E4416A-15A

<u>SERVICE NOTE</u>

E4416A - EPM-P Power Meter

Power Meter Display Shrink

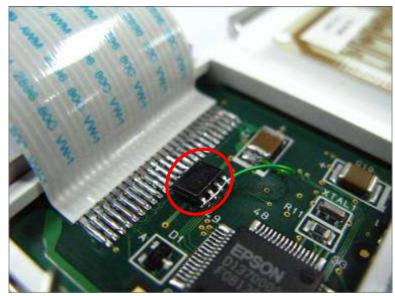
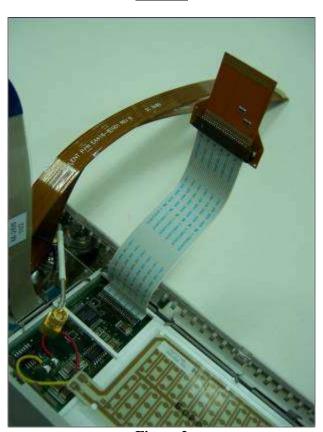
Due to some issues with the implementation of new LCD display controller in the power meter's display, intermittent display shrink is observed when operating the power meter. This however doesn't impact all the units. The display shrink scenario may look like something shown below:

To resolve this problem, replace the front panel assembly with a good one. A good front panel has additional Transient Voltage Suppress (TVS) diode soldered on its PCA **OR** additional ribbon cable with Damping Resistors attached to it. The photos for good front panel assembly are shown below. Additional of TVS diode **OR** Damping Resistors will prevent the display shrink from happening.
